TRANS/WP.29/GRB/2001/6  
18 June 2001

PROPOSAL FOR DRAFT AMENDMENTS TO REGULATION No. 51

(Noise of M and N categories of vehicles)

Transmitted by the Expert from Germany

Figure 1a

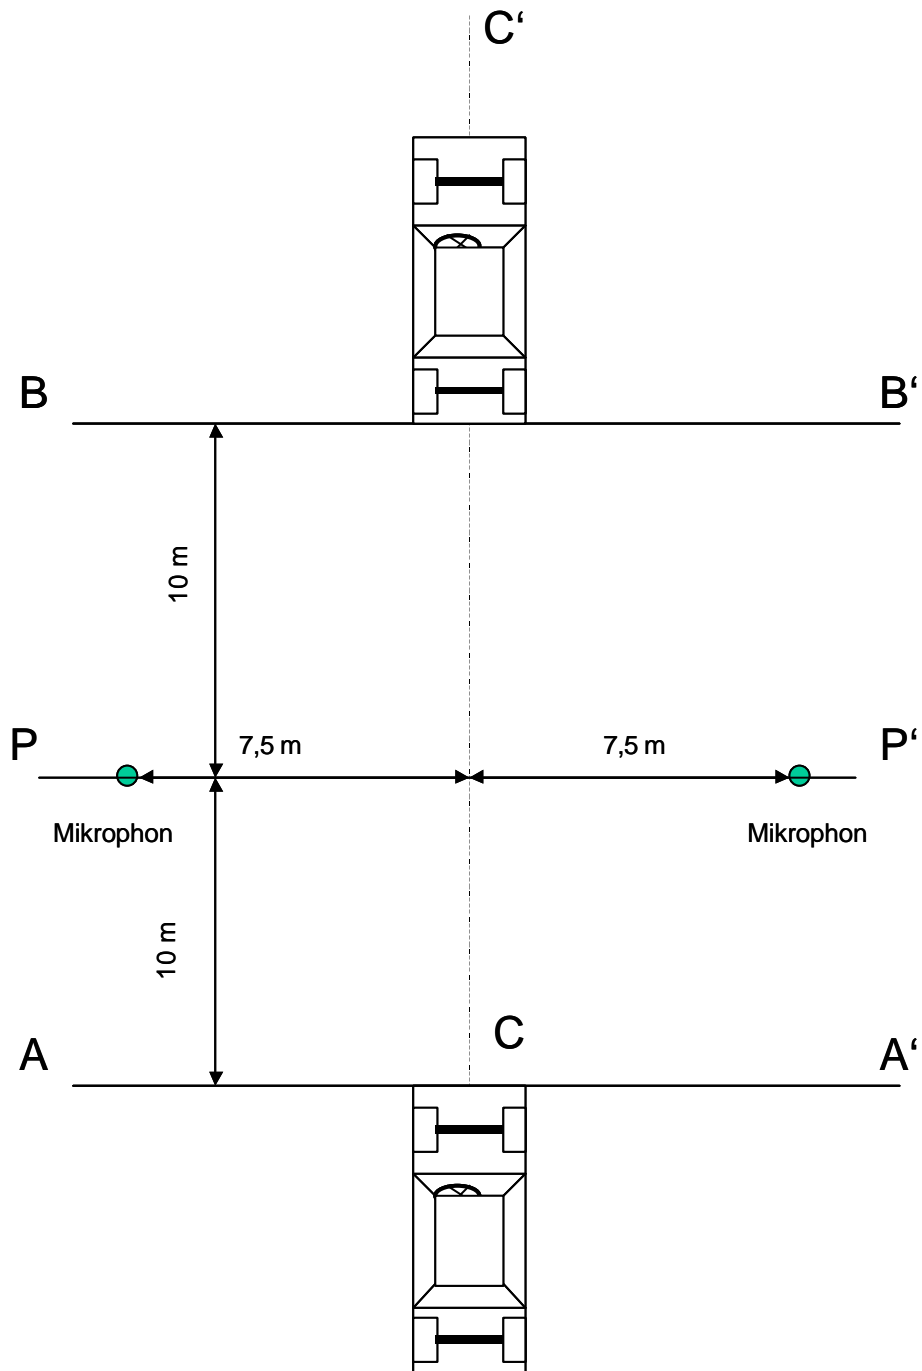
Annex 3, appendix, figure 1, amend to read:

"Measuring position for vehicles of categories M<sub>1</sub> and N<sub>1</sub>

When the front of the vehicle reaches the line AA', the accelerator control shall be fully engaged as rapidly as practicable and held in the fully-engaged position until the rear of the vehicle crosses line BB' (appendix, figure 1a), the accelerator control shall then be released.

- lines AA' and BB', in the case of vehicles of categories  $M_1$  and  $N_1$  (see appendix, figure 1a);
- lines  $H_S H_S'$  and  $H_e H_e'$ , in the case of vehicles of categories other than  $M_1$  and  $N_1$  (see appendix, figure 1b),

Figure 1b"

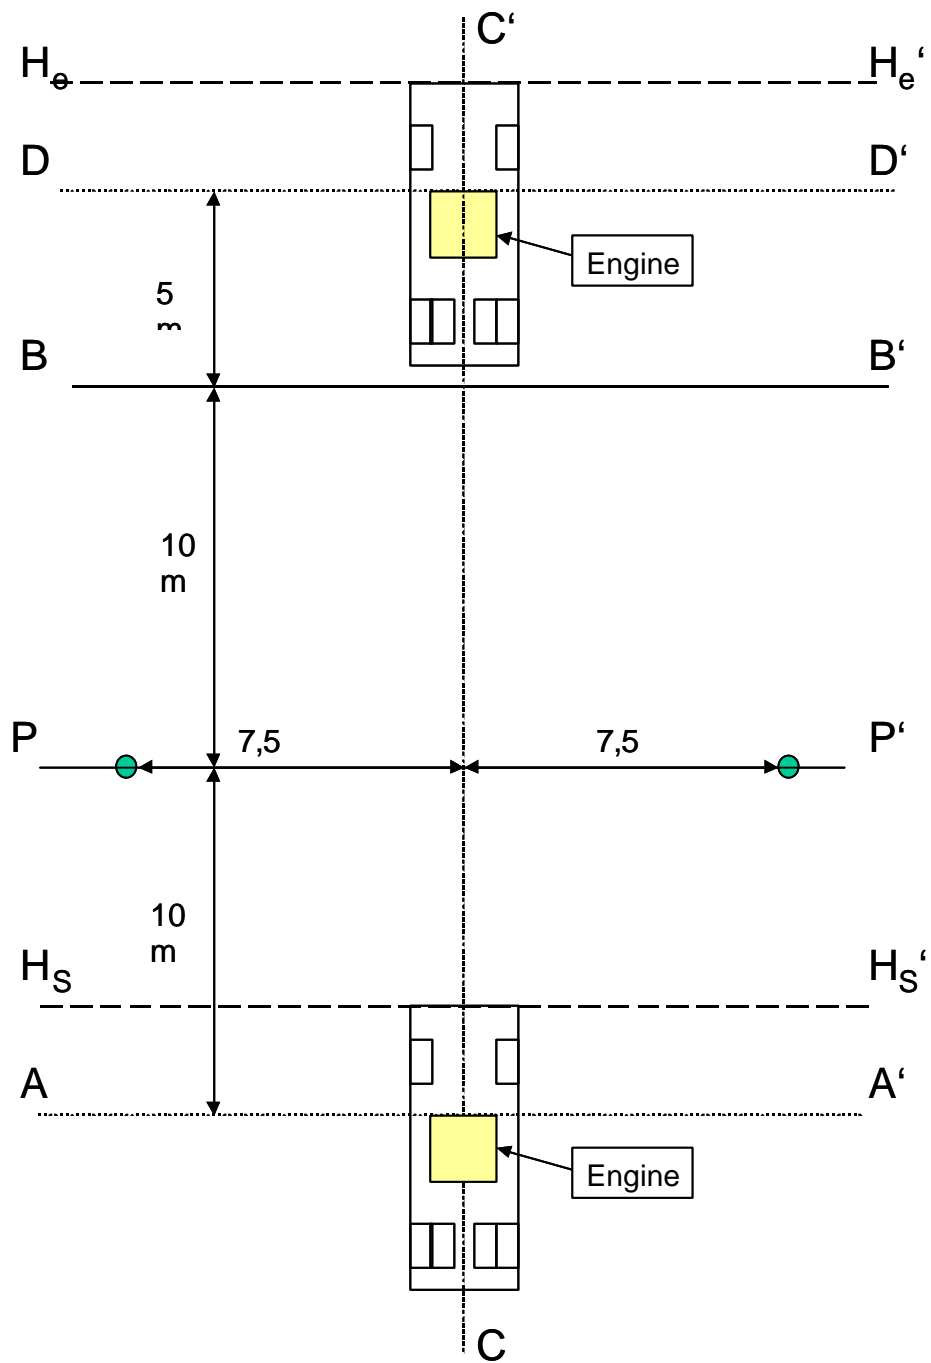
Measuring position for vehicles of categories other than  $M_1$  and  $N_1$

When the front of the engine reaches the line AA', the accelerator control shall be fully engaged as rapidly as practicable and held in the fully-engaged position until the front of the engine crosses line DD' (see appendix, figure 1b), the accelerator control shall then be released.

Line DD' is parallel to line PP' and situated respectively 15 m forward of line PP' (see appendix, figure 1b). For practical reasons the two lines  $H_sH_s'$  and  $H_eH_e'$ , which are related to the front of the vehicle may be marked out on the test runway (see appendix, figure 1b).
